# **ADDENDUM**

Reference: Cannon Health Building

> **Plumbing Improvements** DFCM Project. # 06140390

Subject: Addendum No.1

#### SHEET - PD-102

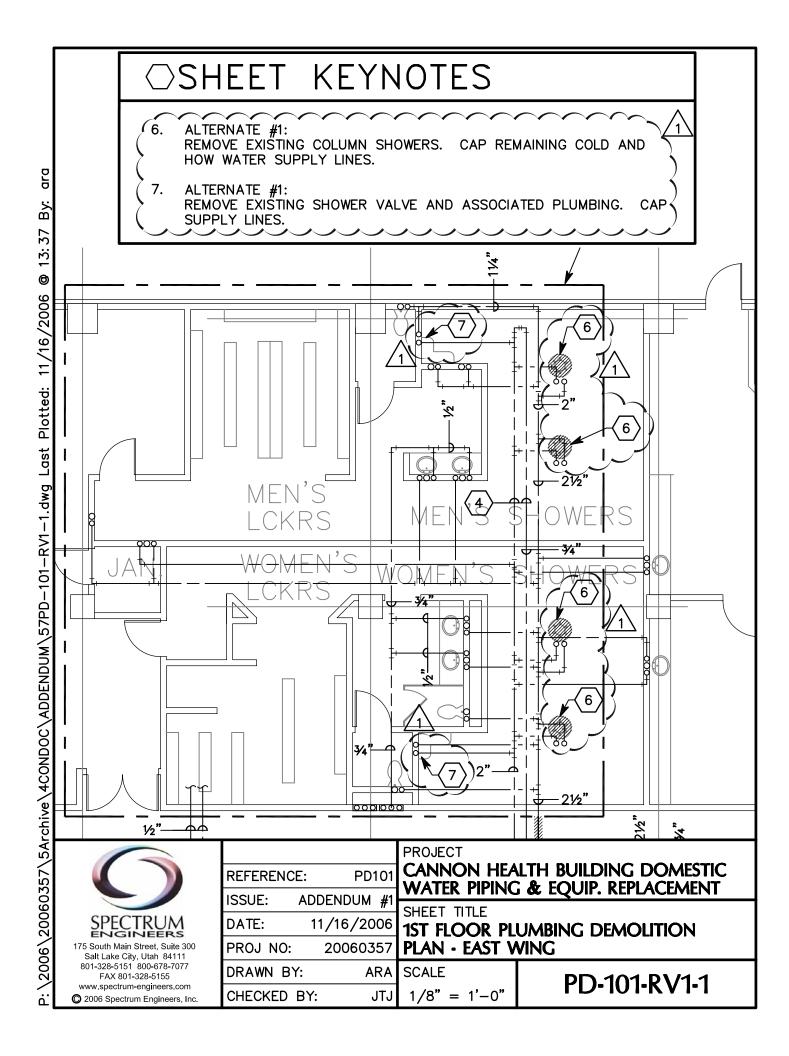
1. An alternate to remove existing showers and shower valve and replace them with pressure balance valves has been added. See sheet PD-101-RV1-1.

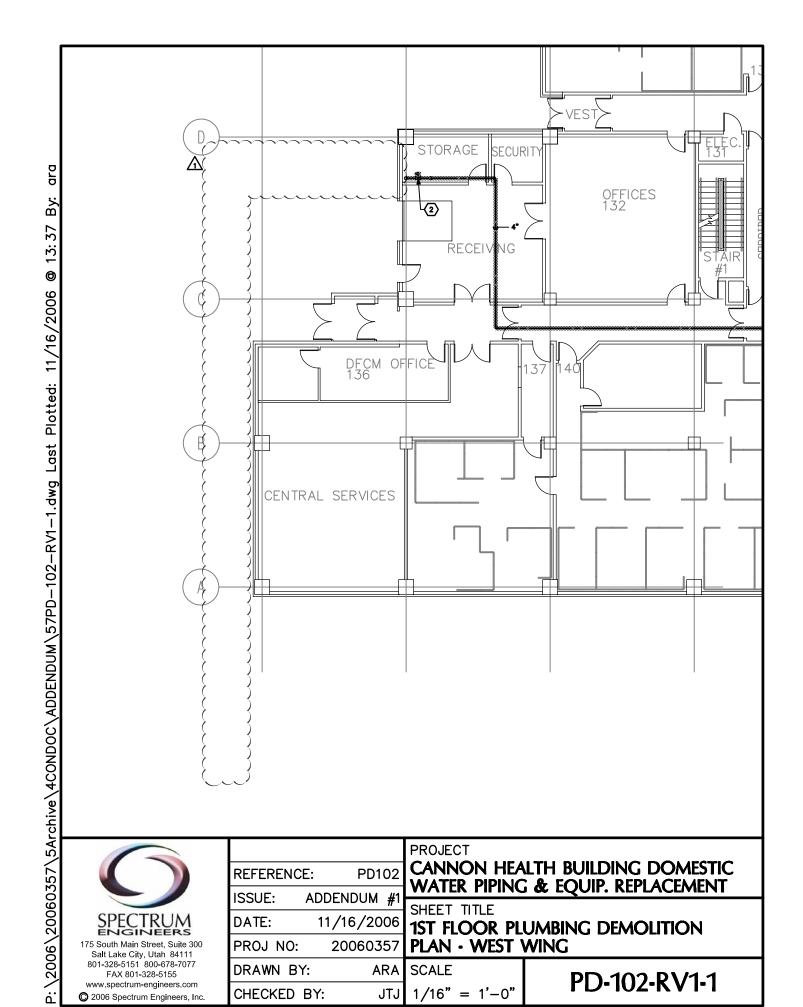
1. The alternate to replace the water main to the water meter has been removed. See sheet PD-102-RV1-1.

PL-101-RV1-1

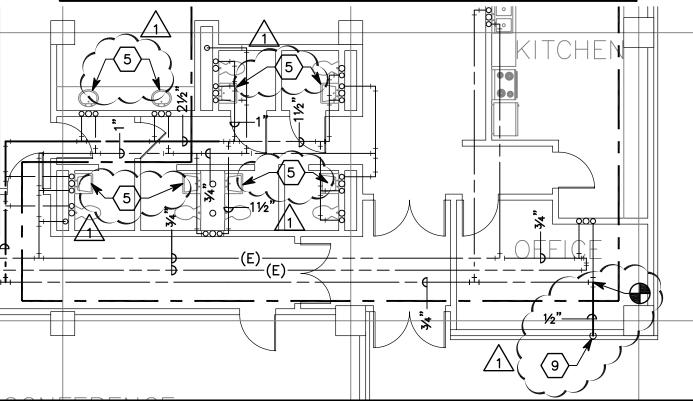
- An alternate to furnish new pressure balance valves and showers has been added. A rough-in for a future outdoor drinking fountain has been added. See sheets PL-101-RV1-1 and PL-101-RV1-2
- 2. The new copper cold water main is to be run above offices as it currently does. See sheet PL-101-RV1-3.

- 7. ALTERNATE #1:
  FURNISH NEW COLUMN SHOWERS WITH 6 HEADS PER COLUMN
  AND PRESSURE BALANCE VALVES FOR EACH HEAD: BRADLEY
  MODEL COL—6C WITH DELUXE SHOWERHEAD WITH LOCKABLE
- 8. SEE SHEET PE601 FOR RISER DIAGRAM.
- 9. ROUGH-IN COLD WATER SUPPLY FOR FUTURE DRINKING FOUNTAIN.

10. ALTERNATE #1:
FURNISH NEW PRESSURE BALANCE VALVE ASSEMBLY:
SYMMONS SAFETYMIX 1-25-FSB WITH HANDLE TURN LIMIT,
WALL/HAND SHOWER WITH FLEXIBLE METAL HOSE, IN-LINE
VACUUM BREAKER, WALL CONNECTION AND FLANGE, AND 30"
SLIDE BAR. INSTALL COMPLIANT WITH ADA REQUIREMENTS.
